P802.1Qdy - RSTP/MSTP YANG – Reusability across SDOs
Murugan Balraj (Nokia)
(murugan.balraj@nokia.com)

This presentation

- Highlights a problem in the proposed YANG model for RSTP, MSTP as part of P802.1Qdy that would prevent its reuse in other SDOs like BBF.
- Presents a possible solution that would allow the YANG model to be reused by other SDOs, but at the same time preserve the overall structure and functionality of the YANG from IEEE 802.1 perspective.
- Highlights some inconsistencies in the data that could arise and possible solution.

Possible inconsistencies

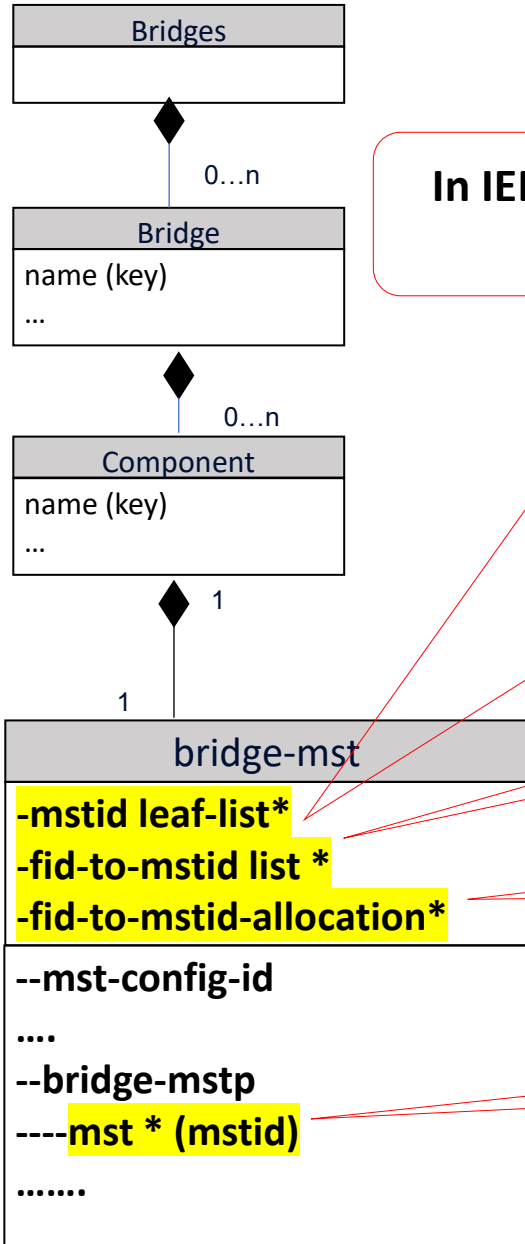
In IEEE P802.1Q-2022-REV , a container “bridge-mst” is defined with an object “mstid” which is a leaflist (/bridges/bridge/component/bridge-mst/mstid)

In IEEE P802.1Q-2022-REV, a container “bridge-mst” is defined which has a list “fid-to-mstid” that also has an object mstid /bridges/bridge/component/bridge-mst/fid-to-mstid/mstid

In IEEE P802.1Q-2022-REV, a container “bridge-mst” is defined which has a list “fid-to-mstid-allocation” that also has an object mstid /bridges/bridge/component/bridge-mst/fid-to-mstid-allocation/mstid

In P802.1Qdy, another list for the mst instance is introduced (/bridges/bridge/component/bridge-mst/bridge-mstp/mst)

Since all the above objects refer to the same MST Instance ID, there could be a different set of values in each of these lists

Possible solution

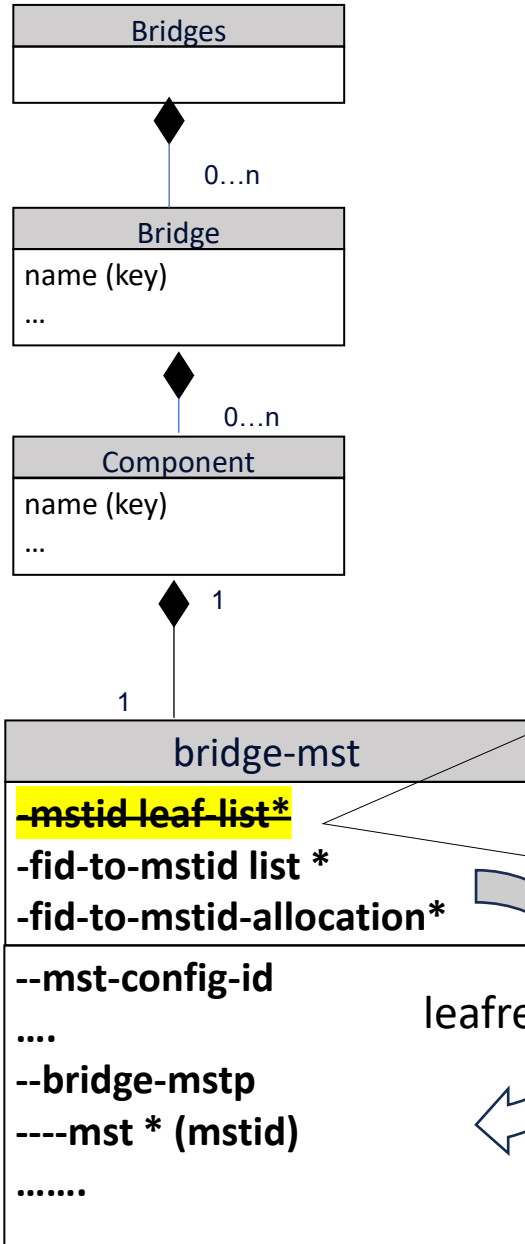
Avoiding inconsistent configuration and/or redundant data may require modifying the YANG objects specified in IEEE Std 802.1Q-2022 under “/bridges/bridge/component/bridge-mst”.

- Would it be acceptable to remove the “mstid” leaf-list from IEEE Std 802.1Q ?
- The list /bridges/bridge/component/bridge-mst/bridge-mstp/mst proposed as part of P802.1Qdy should be sufficient to configure the MST instances. This list would be the main list/configuration for the set of MST instances in each Bridge component.
- If there is a need to refer/specify the “mstid” anywhere else in the YANG tree, a “leafref” type could be used.
- E.g. In the two lists “fid-to-mstid” and “fid-to-mstid-allocation”, the definition of “leaf mstid” could be changed from “type dot1qtypes:mstid-type” to “type leafref”.
- Also, these two lists would need to be moved to the newly proposed IEEE 802.1 specific YANG module “ieee802-dot1q-mstp-bridge” (since these would need to be augmented to Bridge-component).

Ref : [802-1Qdy-d2-0.pdf](#),
Page 19

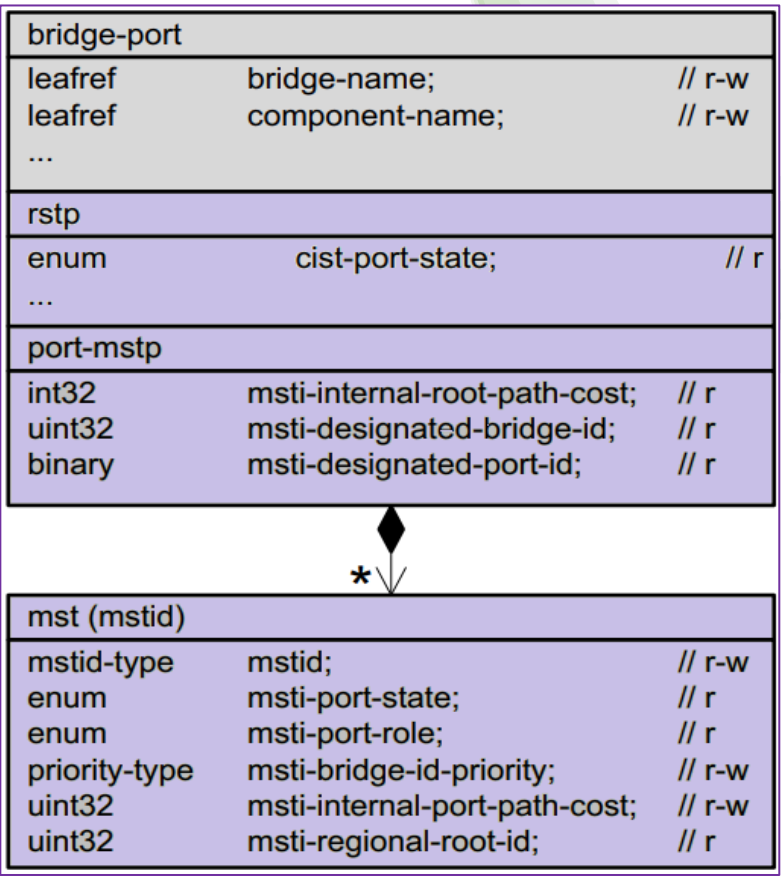
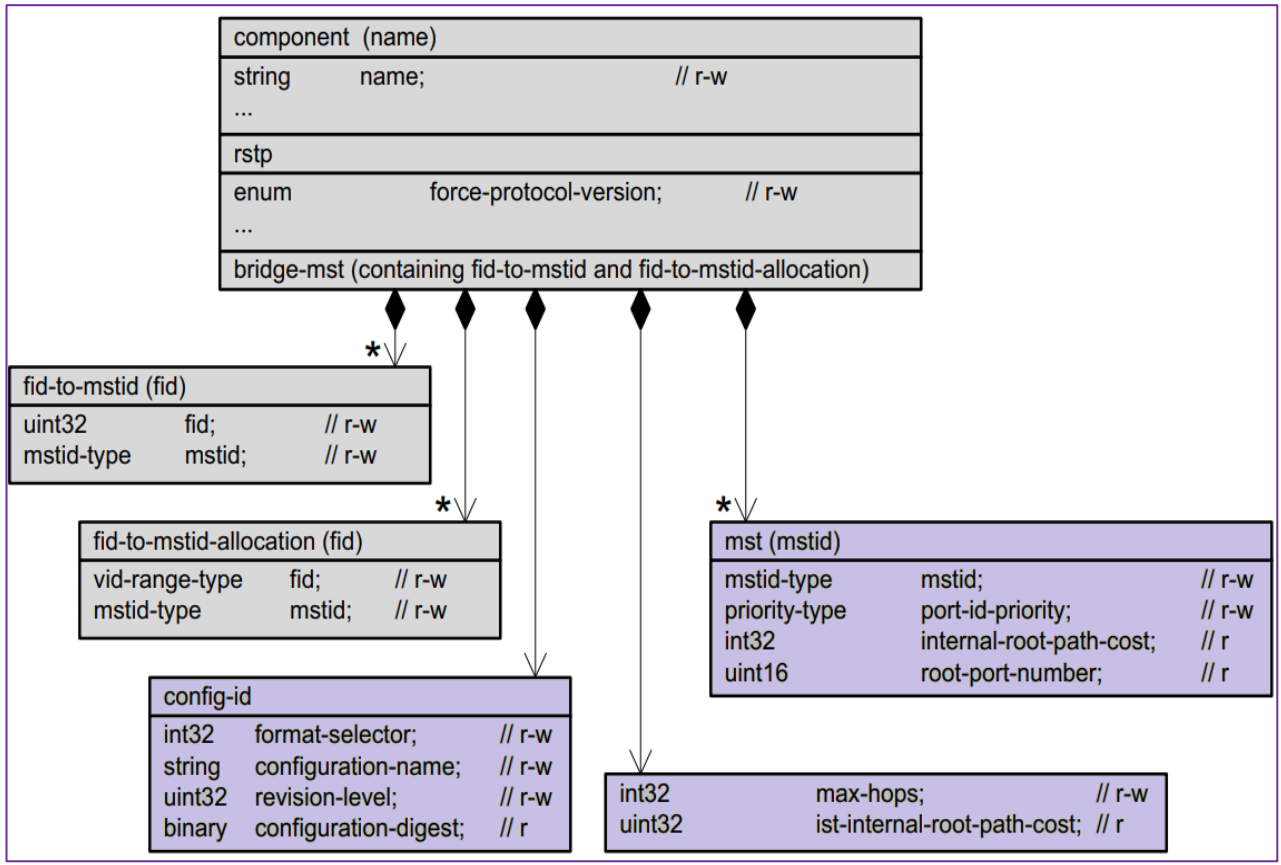
These RSTP protocol specific configuration and state data directly augment "/bridges/bridge/component".

A non-IEEE 802.1 device cannot import this YANG module due to the direct augmentation.

These RSTP protocol specific interface configuration and state data directly augment "/interface/interface/bridge-port".

A non-IEEE 802.1 device cannot import this YANG module due to the direct augmentation.
